Origination Form
Proposed Revisions to a Standard Plans Index

Originator:	Turley, Joshua	Index Number:	700-020
Date:	5/14/2025	Sheet Number(s):	Sheet 1
E-mail:	Joshua.Turley@dot.state.fl.us	Index Title:	MULTI-COLUMN GROUND SIGN

MULTI-COLUMN GROUND SIGN

INDEX
700-020

SHEET
1 of 3

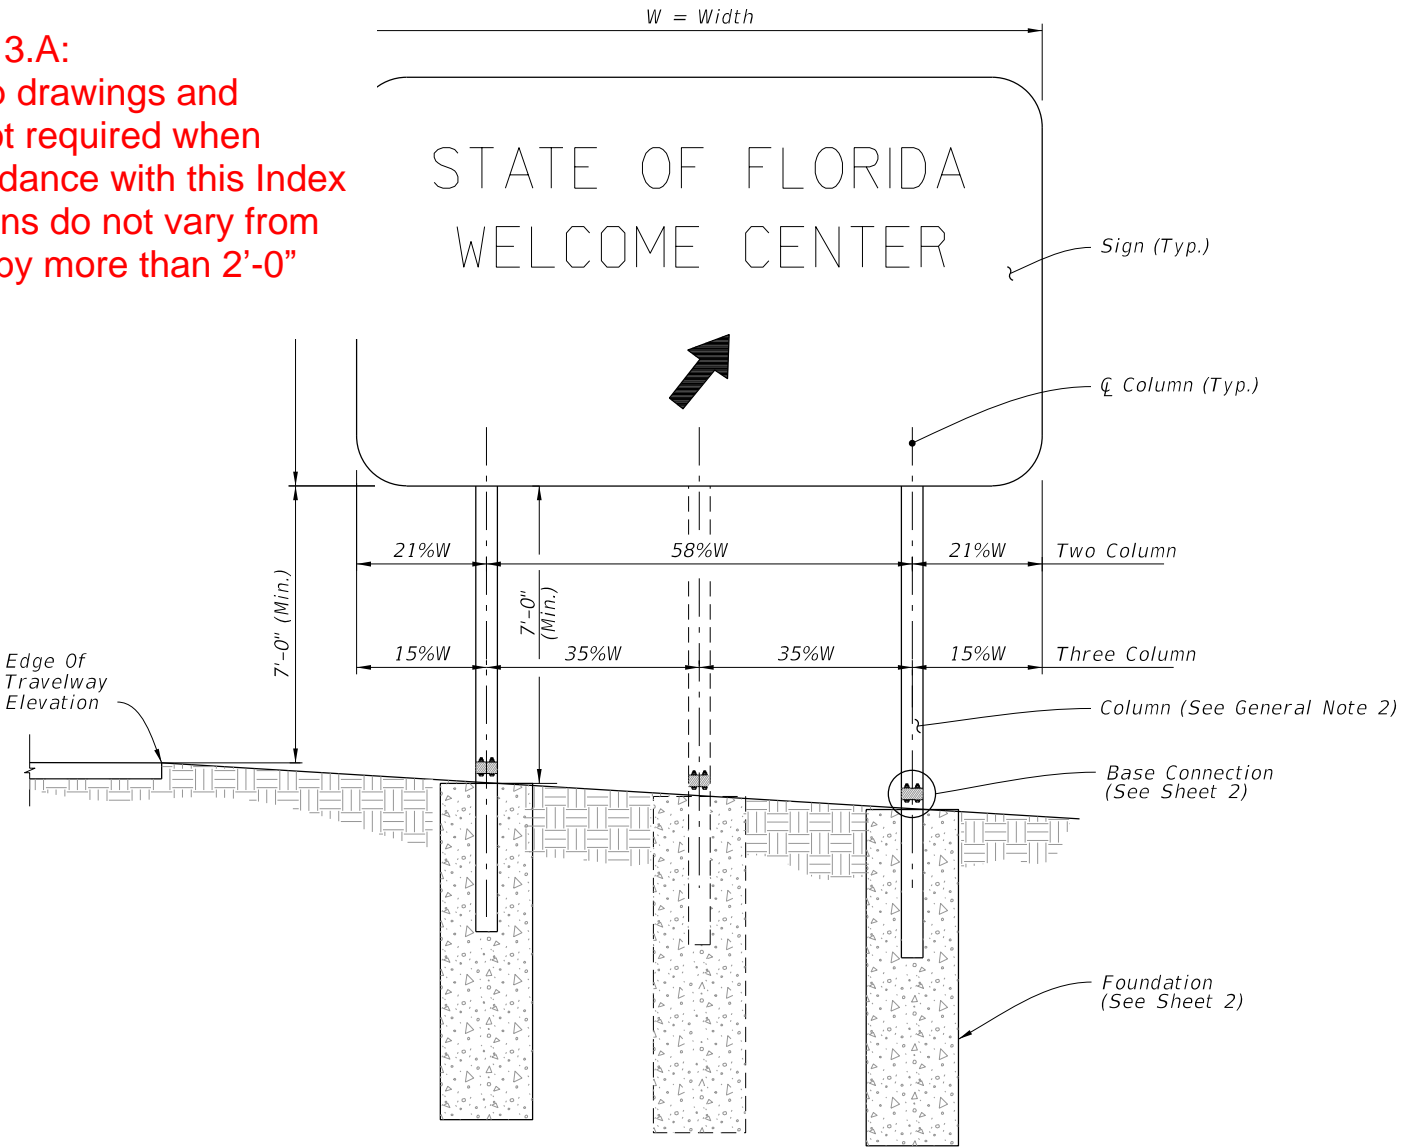
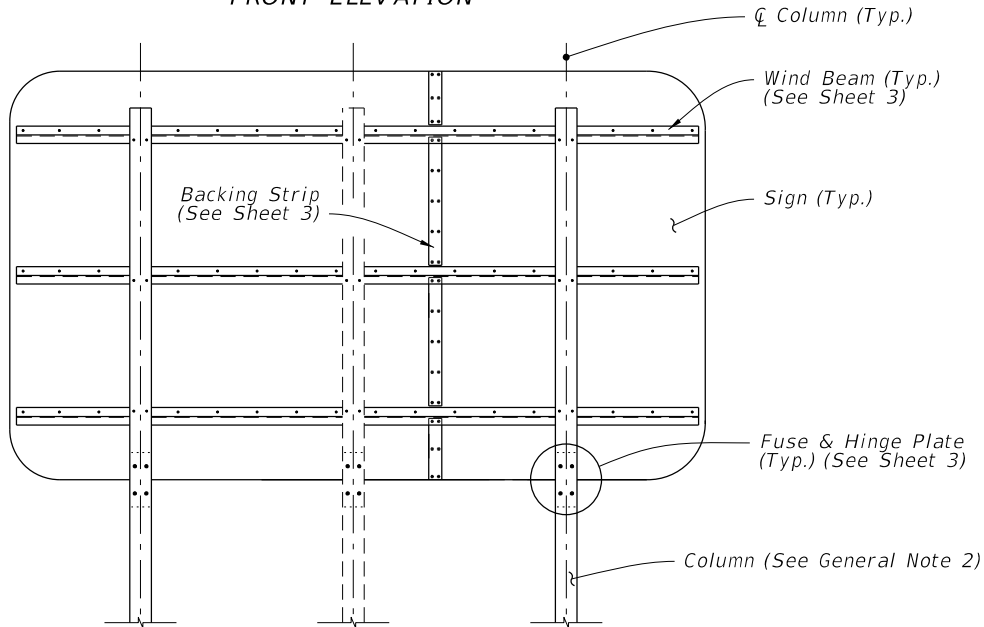
Sheet 1: Modified note 3A for clarity.

There was some confusion of what the 2'-0" allowance meant. It refers to the column locations not for anything in the index.

- ~~A. Sign Support Shop drawings are not required when fabricated in accordance with this Index and support columns do not exceed the width ("W") shown in the plans by more than 2'-0".~~
- B. Sign Panels: Horizontal panel splices are allowed at interior wind beams for sign panels with a height ("H") greater than 10 feet. Shop drawings required for horizontal panel splice details.
- C. When shop drawings are required, obtain approval prior to fabrication.

CHANGED NOTE 3.A:
Sign Support Shop drawings and calculations are not required when fabricated in accordance with this Index and support columns do not vary from the plan locations by more than 2'-0" longitudinally.
